UNITED STATES PATENT AND TRADEMARK OFFICE

APPLICATION NO.	FILING DATE	FIRST NAMED INVENTOR	ATTORNEY DOCKET NO.	CONFIRMATION NO.
10/712,070	11/13/2003	Kotaro Kashiya	80329-0016	7914
23353	7590	12/04/2006	EXAMINER	
RADER FISHMAN & GRAUER PLLC LION BUILDING 1233 20TH STREET N.W., SUITE 501 WASHINGTON, DC 20036			KRAUSE, JUSTIN MITCHELL	
			ART UNIT	PAPER NUMBER
			3682

Office Action Summary

DETAILED ACTION

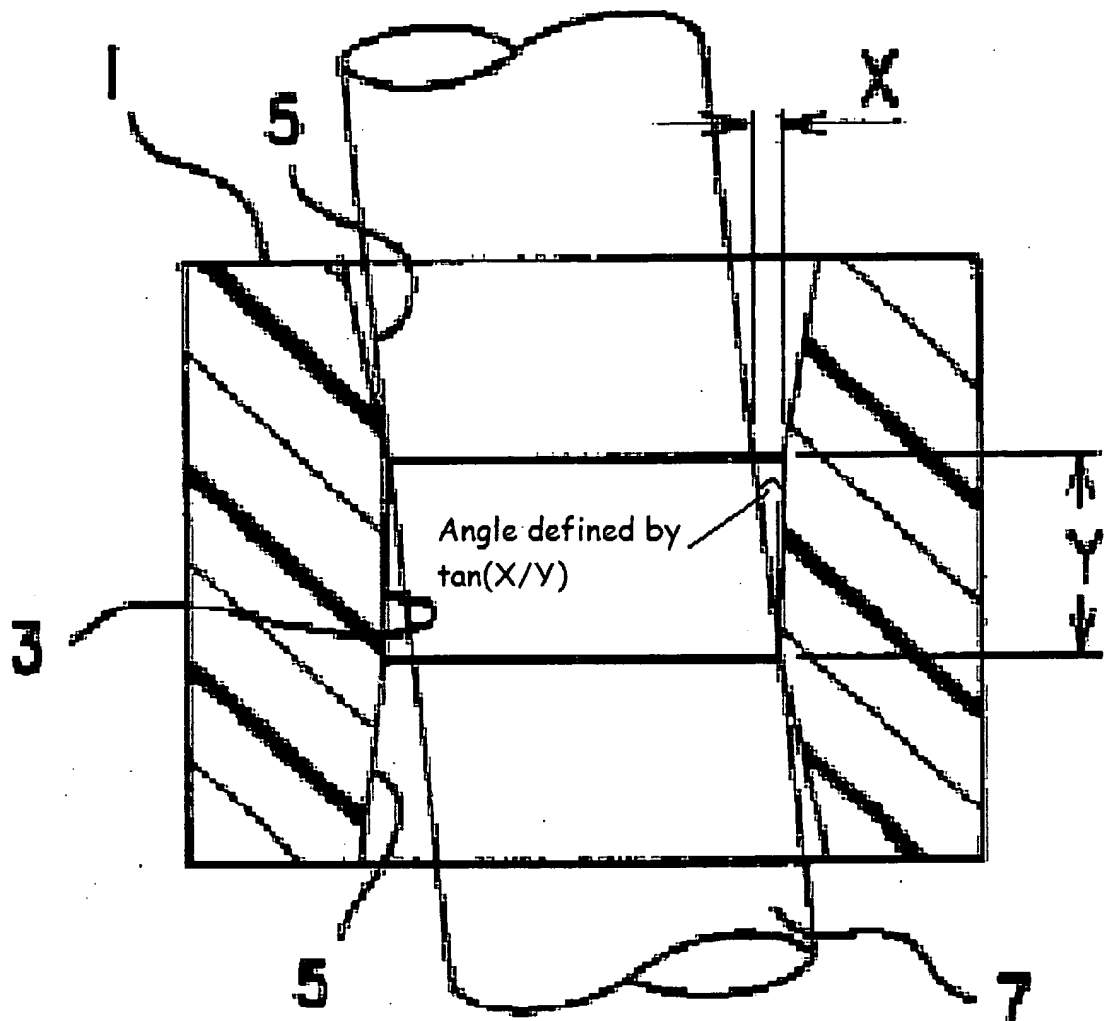
Regarding claim 3, Okada defines a clearance X, between the shaft and sliding surface (Y) and X/Y is greater than or equal to 0.052, where $\tan(X/Y)$ defines an angle between the central axis of the bearing and the angle of the shaft (see fig below).

At a minimum (i.e. $X/Y=.052$), the inverse tangent of X/Y is 2.97 degrees which defines the minimum possible angle of the second and third surfaces and satisfies the limitation that the angle must be between 0.05 and 5 degrees.
